Memorandum to the City of Markham Committee of Adjustment May 1, 2024

File: A/013/24

Address: 57 George Street, Markham
Agent: Paar Design Inc. (Nikol Paar)
Hearing Date: Wednesday, April 3, 2024

APPENDIX "C" CONDITIONS TO BE ATTACHED TO ANY APPROVAL OF FILE A/013/24

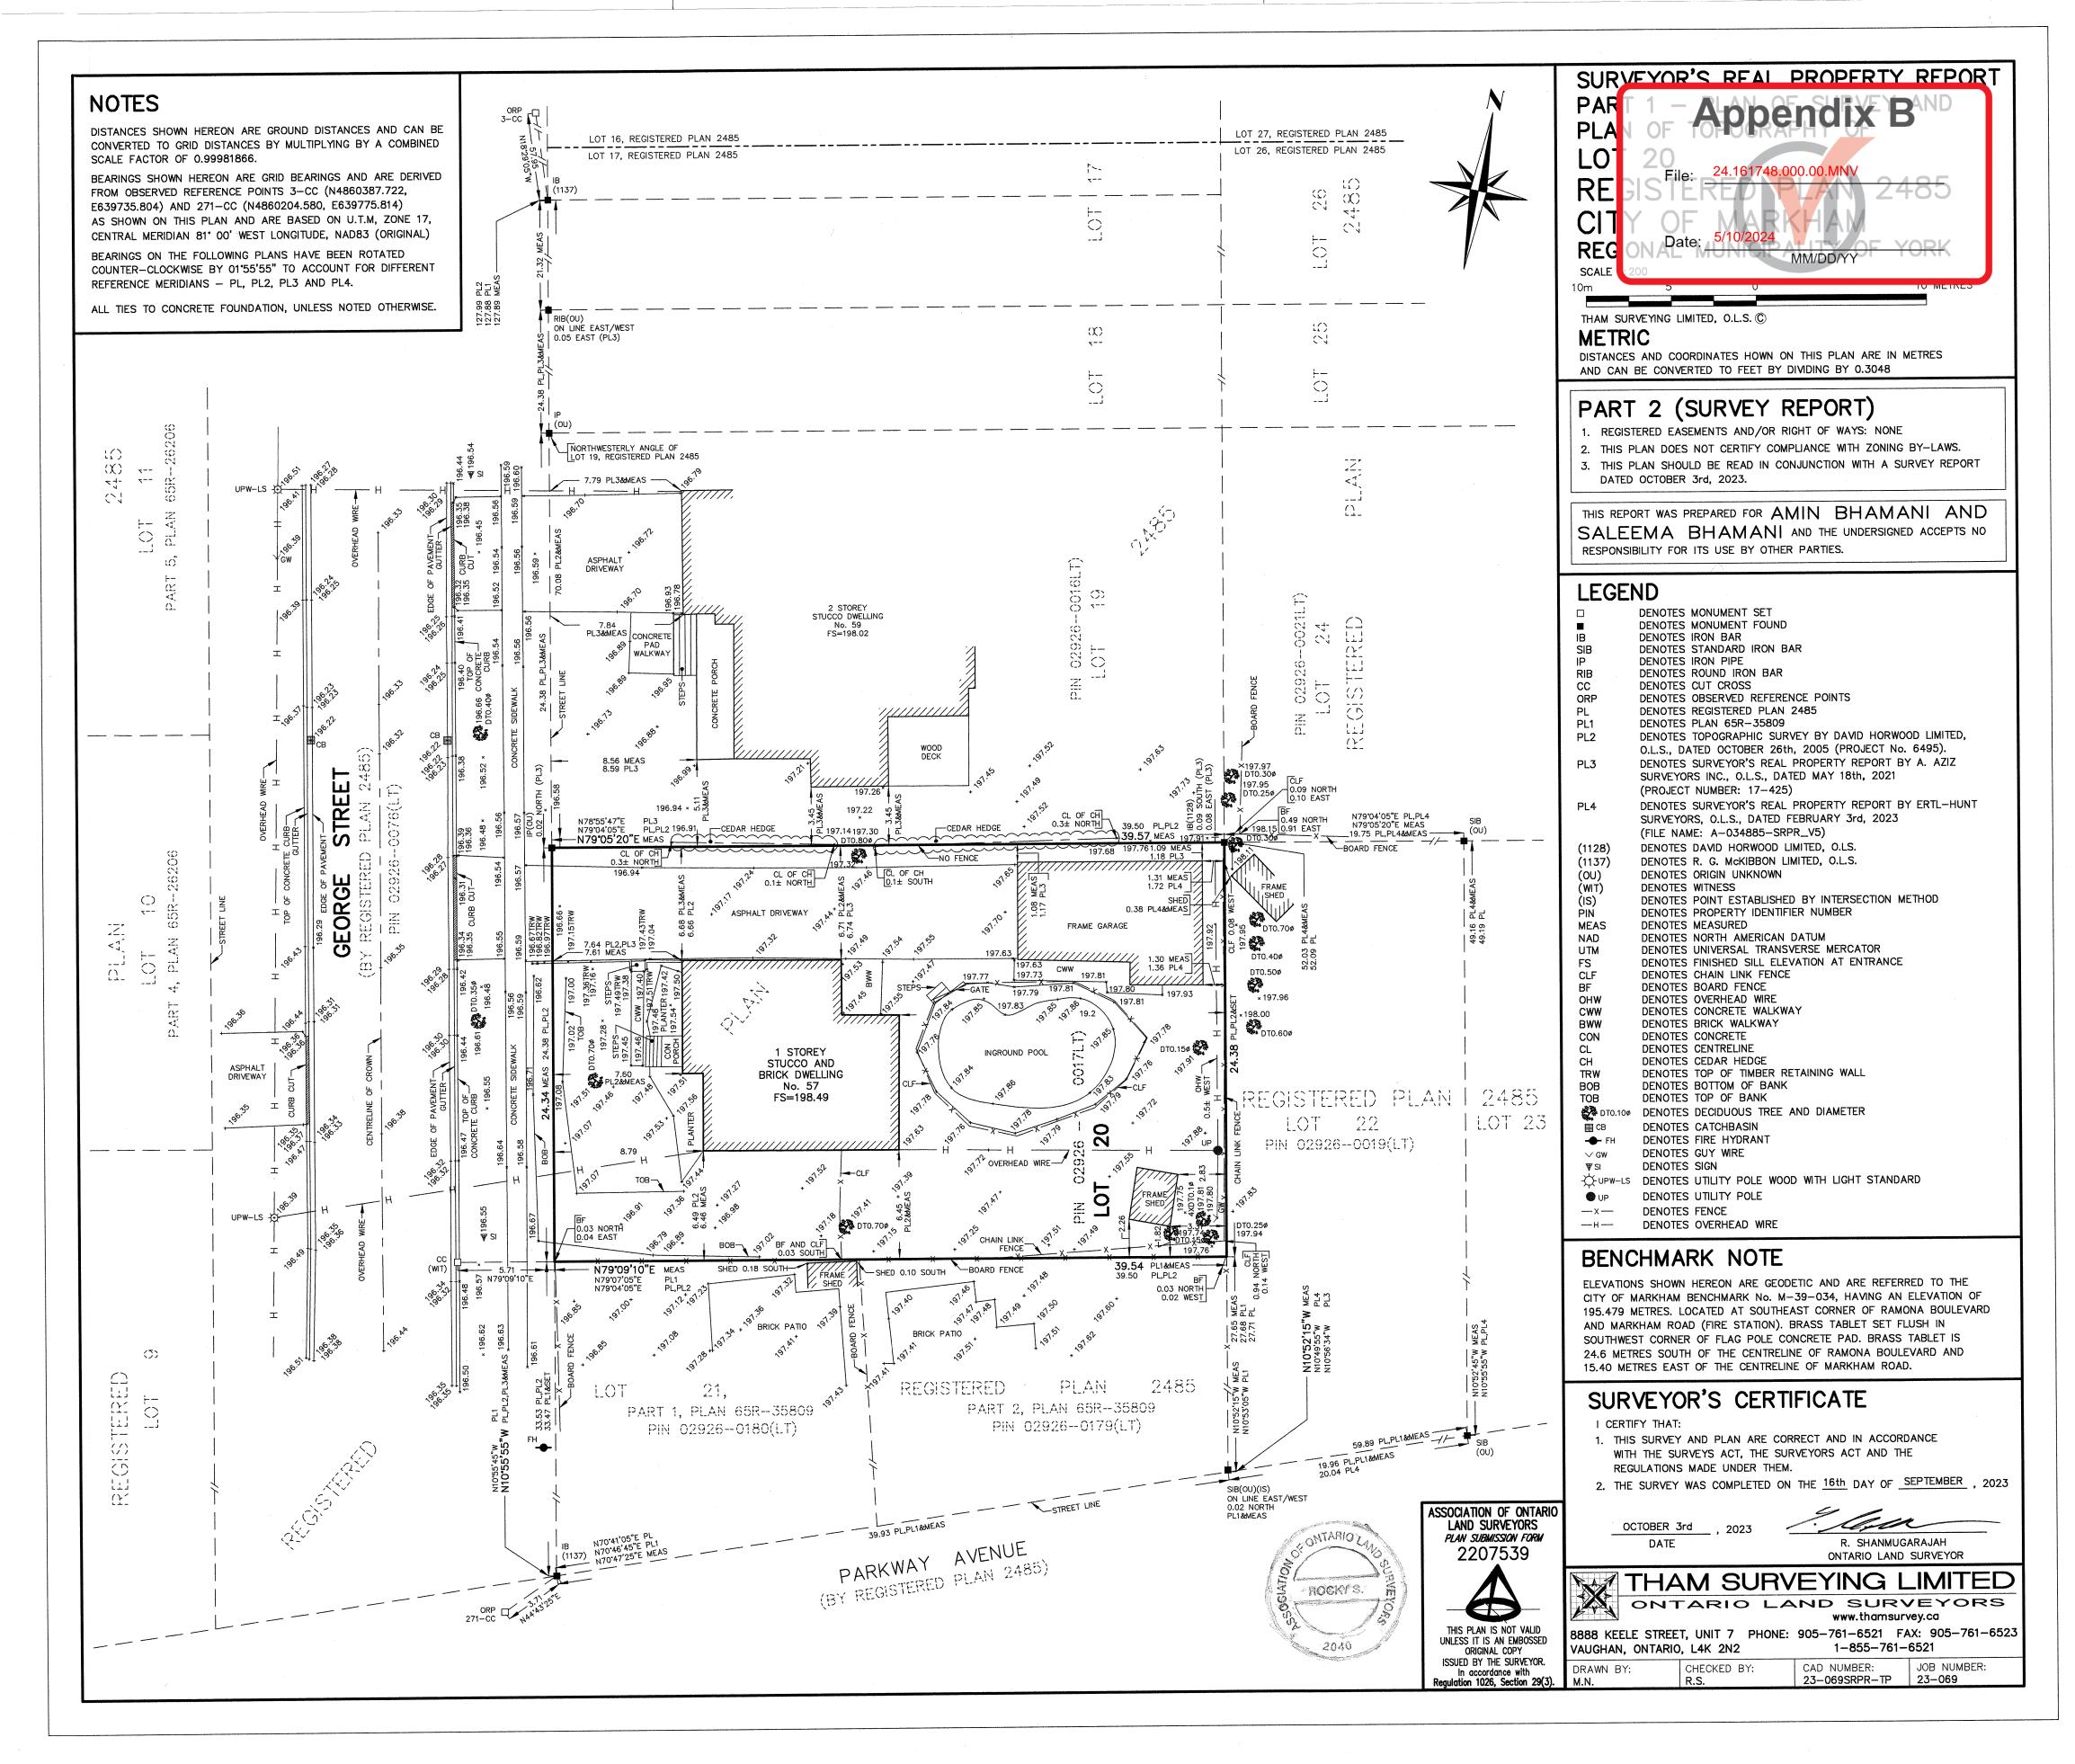
The Applicant is requesting relief to permit a floor area ratio of 48.78 percent, whereas the By-law permits a maximum floor area ratio of 45 percent. The variance will facilitate the construction of a two-storey detached dwelling with a floor area of 384.63 m² (4,140.11 ft²), whereas the By-law permits a dwelling with a maximum floor area of 354.74 m² (3,818.38 ft²). This represents an increase of approximately 29.89 m² (321.73 ft²).

Floor Area Ratio is a measure of the interior square footage of the dwelling as a percentage of the net lot area however; it is not a definitive measure of the mass of the dwelling. The building layout meets all other zoning provisions (such as setbacks and lot coverage) that establish the prescribed building envelope, which ensures the proposed dwelling will be in keeping with the intended scale of residential infill developments for the neighbourhood.

The intent of maximum floor area provision in the By-law is to ensure that the overall size of the proposed dwelling will be in keeping with the intended scale of residential infill developments in the neighbourhood. Although the gross floor area is aligning with other recent infill development projects within the neighbourhood, it is noted that the floor area ratio reduction subject to this application has predominantly been a result of converting a portion of the garage to a partially enclosed carport instead of a three car garage. The overall scale of the proposed dwelling has remained relatively unchanged, aside from the carport and reduced roof pitch above, which remains a concern to staff.

The Applicant is requesting relief to permit a maximum building depth of 20.10 metres (65.94 feet), whereas a maximum building depth of 16.80 metres (55.12 feet) is permitted. This represents an increase of approximately 3.60 metres (11.81 feet).

The variance includes a front covered porch and rear covered concrete deck which adds approximately 4.25 metres (14 feet) to the overall depth of the building. The main component of the building, excluding the front covered porch and rear covered deck has a depth of approximately 15.21 metres (50 feet), which complies with the By-law requirements. The requested building depth variance is entirely attributable to the proposed front covered porch and the rear covered concrete deck. The proposed dwelling consists of a south side yard setback of 1.83 metres (6 feet), and a north yard setback of 4.83 metres (15.85 feet) and will not result in any impact to abutting properties.

Staff are of the opinion that the variance request is minor in nature and therefore have no concerns with the building depth of the proposed dwelling.
